Docket Item # 8  
BAR CASE # 2010-0070

BAR Meeting  
April 28, 2010

**ISSUE:** New Construction (Phase II, James Bland Redevelopment)

**LOCATION:** 801 Madison Street

Figure 13. Site lines of various units depicting visibility of rooftop solar collectors.

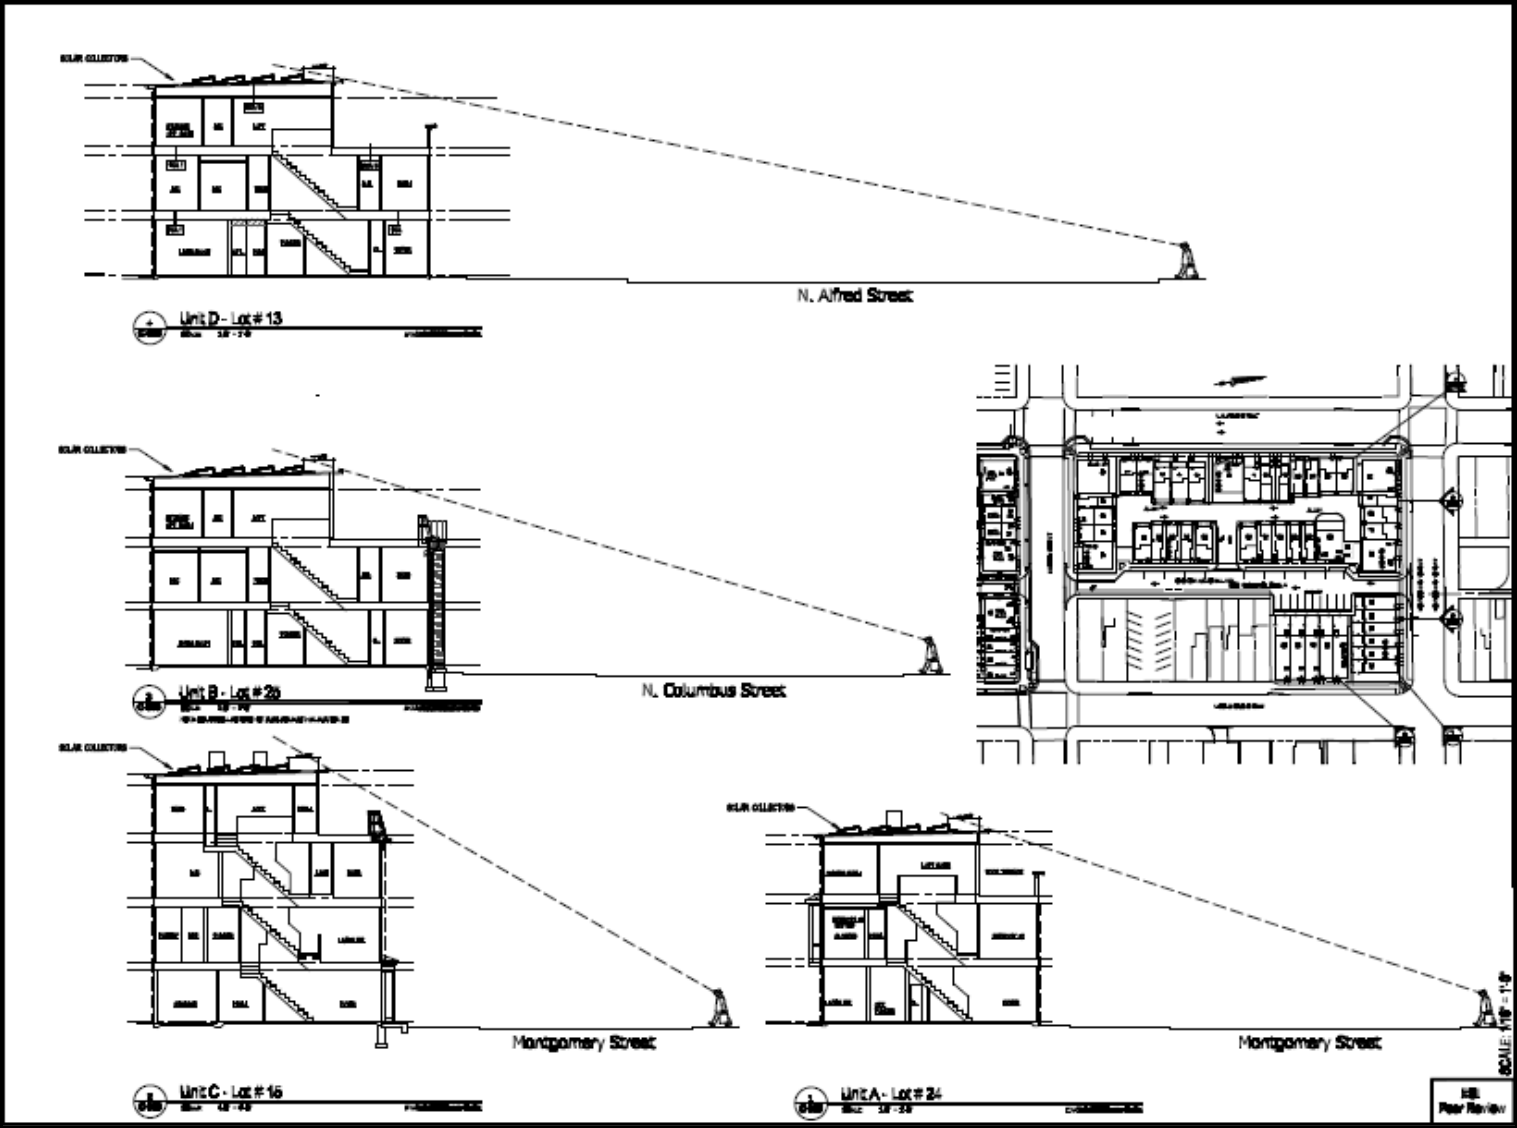
Staff proposes to treat the approval of the solar collectors similar to the proposed condition for rooftop HVAC condensers. The applicant proposes to install the necessary hardware for six solar panels to be located on the roofs of most unit types. Installation of the units themselves will be the responsibility of the future property owner. The solar panels specified by the applicant would measure roughly 6 feet by 5 ¼ feet. They would be placed at an angle, with the highest point 14 inches above the flat roof in order to maximize exposure to the sun. Instead of returning to the BAR for approval of the solar collectors on each unit, Staff recommends that the developer work with BAR Staff to determine the appropriate location of the future solar collectors to insure minimal visibility based on mock-ups in the field.

2. That the location of the solar collectors on the individual townhouses be approved by BAR Staff prior to their installation to insure they are minimally visible;

Figure 17: Detail of alley dwelling door with lintel and canopy.

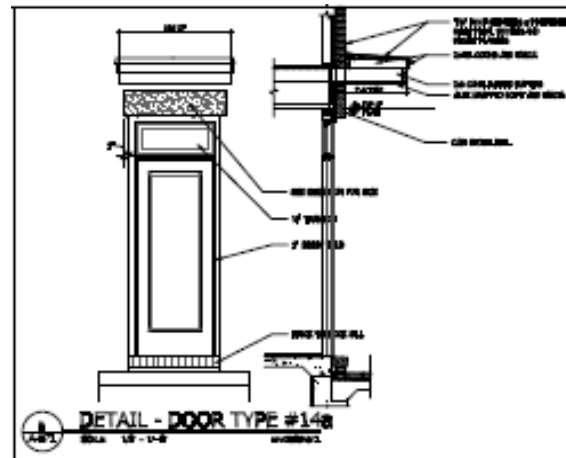
With respect to the alley dwellings, the “skin” of these units has been revised to provide architectural variety. Both Staff and the BAR strongly encouraged the applicant to utilize a different design vocabulary for the buildings in Phase II, given that the same alley style dwelling will be located in Phase I, Phase II and Phase III. The applicant was encouraged to look at the existing Art Deco buildings in the historic district as a guide. The changes include: the addition of split face concrete block at the first floor; canopies over the doors of some units; full light wood doors; balcony railings at the loft level; the use of a herringbone pattern on the projecting bays; and, a change in the color scheme. While nothing has changed on the interior of these units, they have an entirely different expression than the more industrial style units in Phase I. Staff commends the applicant for making this change and looks forward to seeing the design of the alley units in Phase III. Staff’s only recommendation is that the lintels below the proposed new canopies be deleted or restudied, as they seem to visually compete with the canopy immediately above.
